# UNITED STATES PATENT AND TRADEMARK OFFICE

APPLICATION NO.	FILING DATE	FIRST NAMED INVENTOR	ATTORNEY DOCKET NO.	CONFIRMATION NO.
09/752,879	12/28/2000	Aditya Mukherjee	42390P9572X	9416

### FINAL OFFICE ACTION

FIG. 1

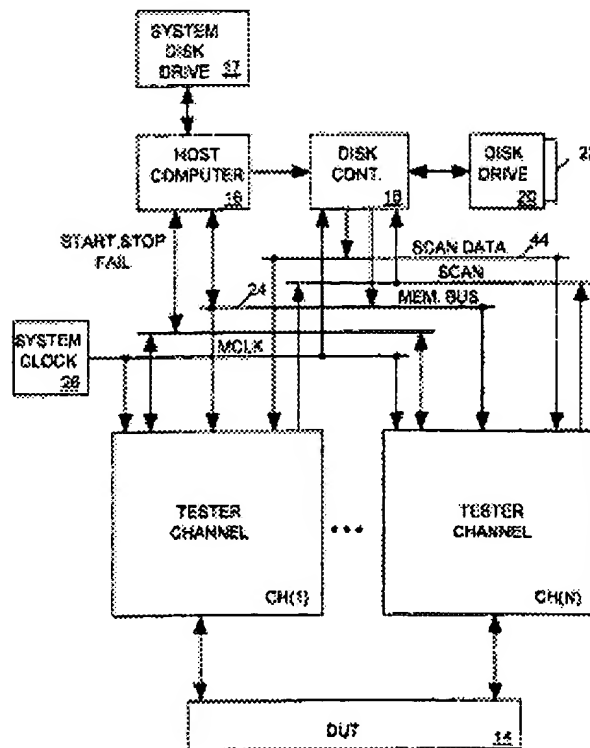
As per **Claims 1, 6, 11, 16**, **Wasson** substantially depicts, in Figs. 1-2 and related description in col. 1 line 10 et seq., the claimed apparatus or system or means circuit comprising: internal data bus (col. 2 line 55, or Fig. 1 numeral 24); plural clusters coupled to said bus with data signal synchronizing means for data signals there-through (Fig. 1 CH1..CHN); test controller coupled to said bus (col. 4 line 45 or col. 6 line 50 et seq., as seen in Fig. 1 Blocks 16 and 18); and a debug or tester or tester unit coupled to said bus (col. 4 line 47 et seq.) wherein the bus is configured to generate system or global control signal (at col. 4 lines 46 et seq.) and each of said plural clusters configured to generate local or separate control signals at col. 4 lines 49 et seq., wherein an IC embeds said ITC, clock controller means and entire tester components within a monolithic integrated circuit, e.g., in Fig. 1 and col. 3 line 45.

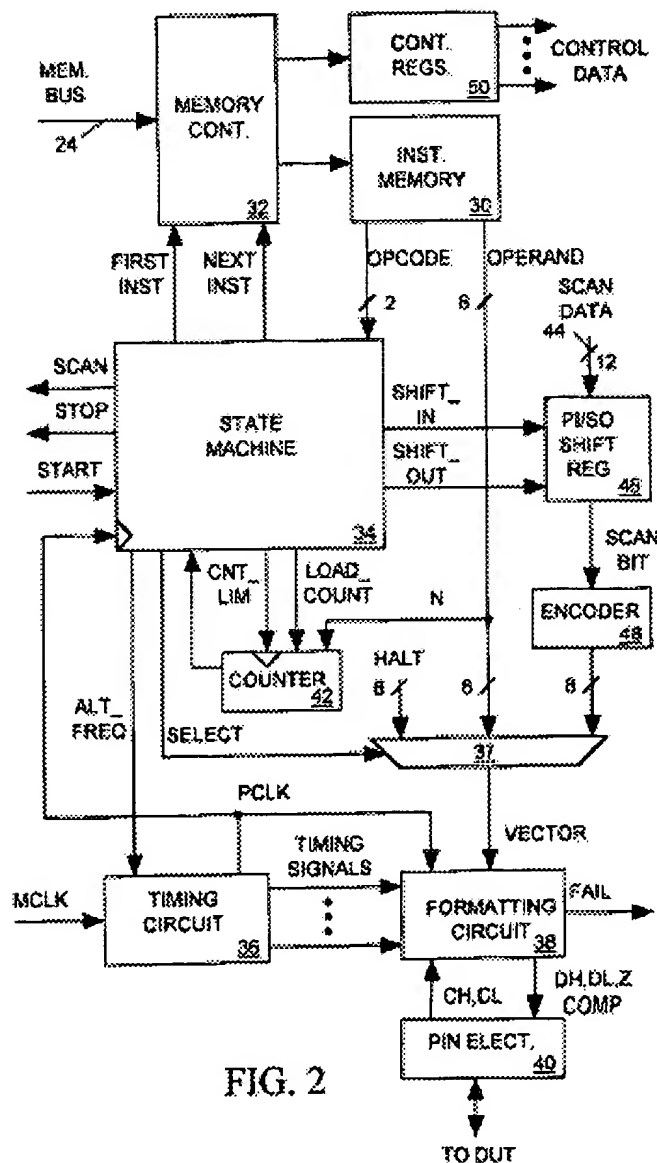
**Accordingly**, such ITC so configured is well known as being part of an integrated circuit, said IC having a self-test feature. It is also well known that some ICs comprise built-in self-testing (BIST) capabilities thereby obviating the need for a bulky/expensive external tester and costly maintenance associated therewith. For instance, **Attaway et al.** incorporates such design approach for a BIST system as depicted in Fig. 4 wherein *interface 10* comprises a *finite state machine 50* and an *instruction register 52*. {See **Attaway et al.**, Id., e.g., col. 3 line 25 for IEEE 1149.1 standard, col. 5 lines 34 for TAP finite state machine, col. 4 line 39 for instruction register, and RAM and *RAM BIST 40*.}

**Therefore**, it would have been obvious to a person having ordinary skill in the art at the time the invention was made to modify the IC tester of **Wasson** by including therein TAP state machine and instruction register with a BIST system as taught by **Attaway et al.**, because such modification would provide the testing procedure of **Wasson** with a method whereby the testing system not only complies with the IEEE 1149.1 standard but also is cost efficient because such design minimizes test hardware overhead and eliminates operator intervention in test mode. {See **Attaway et al.**, Id., Fig. 4: block 10.}
